AIRWORTHINESS DIRECTIVE GLIDERS/POWERED SAILPLANE      GFA/AD 209    S.Z.D. 16

GLIDER/POWERED SAILPLANE TYPE:      BOCIAN 1 E up to Serial No. 787

SUBJECT:      Replacement of Front cockpit shoulder harness anchorage point.

BULLETIN Nr BR - 10/77 B O C I A N 1E

Fig. nr 1

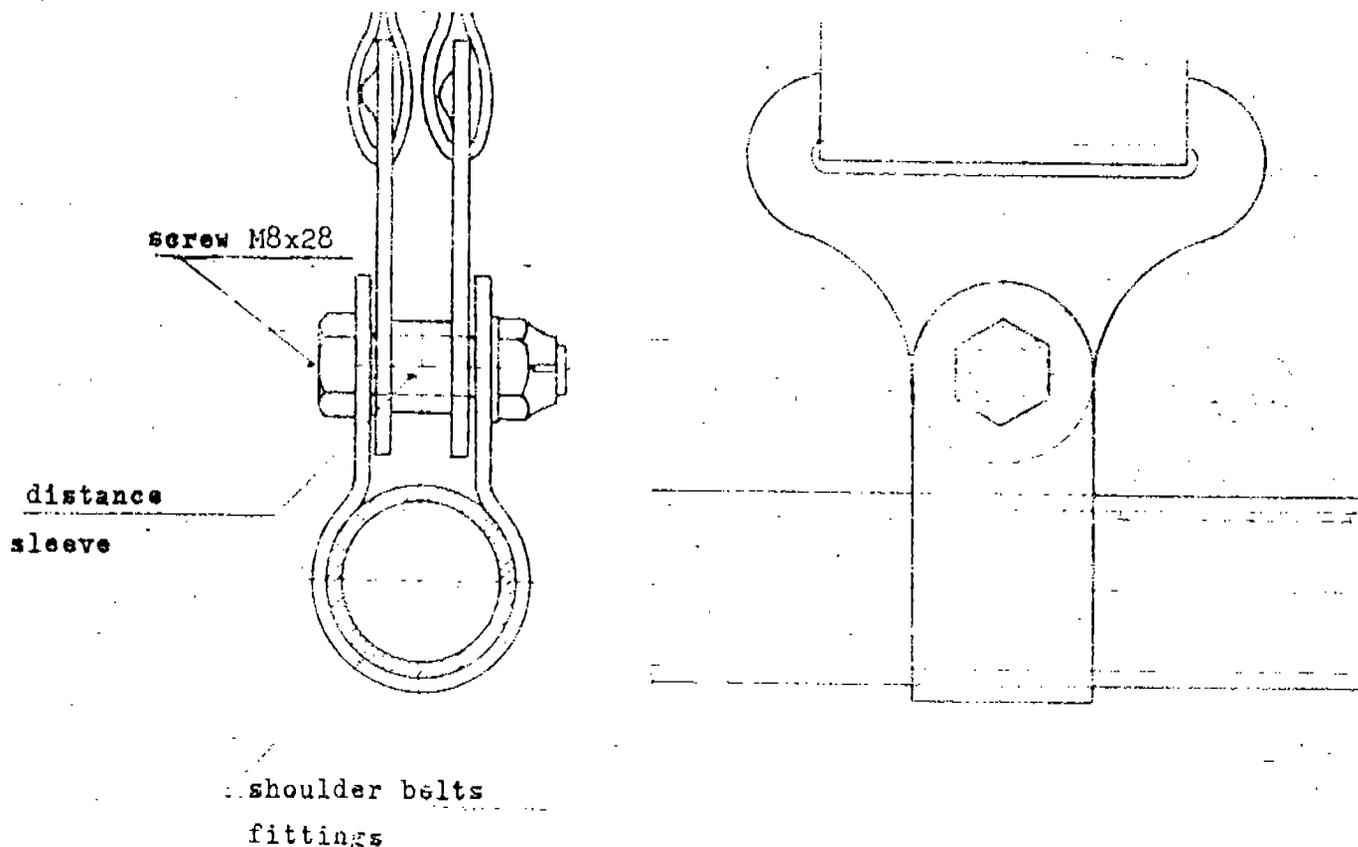
In respect to the appearance of faults in fixing of shoulder belts in front cockpit the new fitting has been introduced.

The front cockpit shoulder belts should be disassemble. The fittings to which the belts were fixed should be cut off and filed to avoid the sharp edges. The places of cutting should be protected with the primer and lacquer. Then installed the fitting made acc. to fig. nr 2 should be installed.

INSTALLATION OF SHOULDER BELTS FITTING
